Watts Bar Nuclear Plant, Unit 2
NRC Docket No. 50-391

Subject: WATTS BAR NUCLEAR PLANT (WBN) UNIT 2 – PRELIMINARY REQUEST FOR ADDITIONAL INFORMATION REGARDING FINAL SAFETY ANALYSIS REPORT (FSAR) AMENDMENT 94, SECTION 2.3, “METEOROLOGY”

Watts Bar Nuclear Plant Unit 2 Request for Additional Information Final Safety Analysis Report, Amendment 94 Section 2.3, "Meteorology"

FIGURE 2.3-3

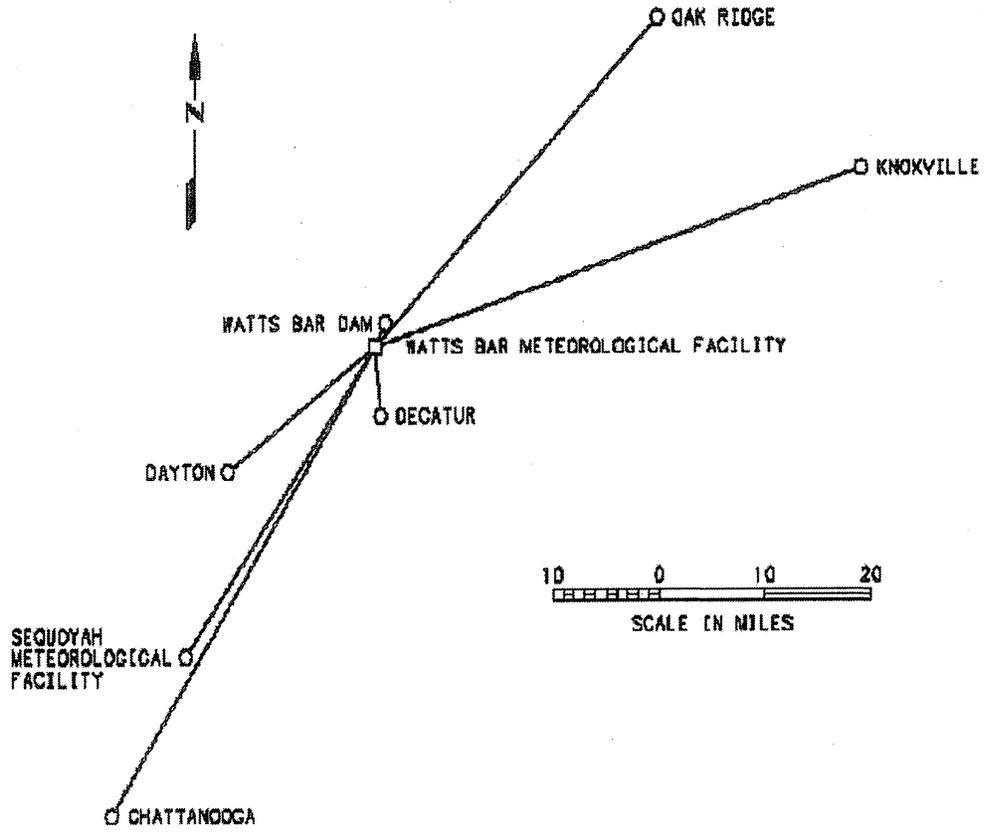
Table	Discussion of Changes and Impact on Text
	Also, Figure 2.3-3 (Refer to Attachment to this Enclosure) was revised to add Dayton. Decatur was retained in the figure to show that Dayton is equivalent (with respect to distance).
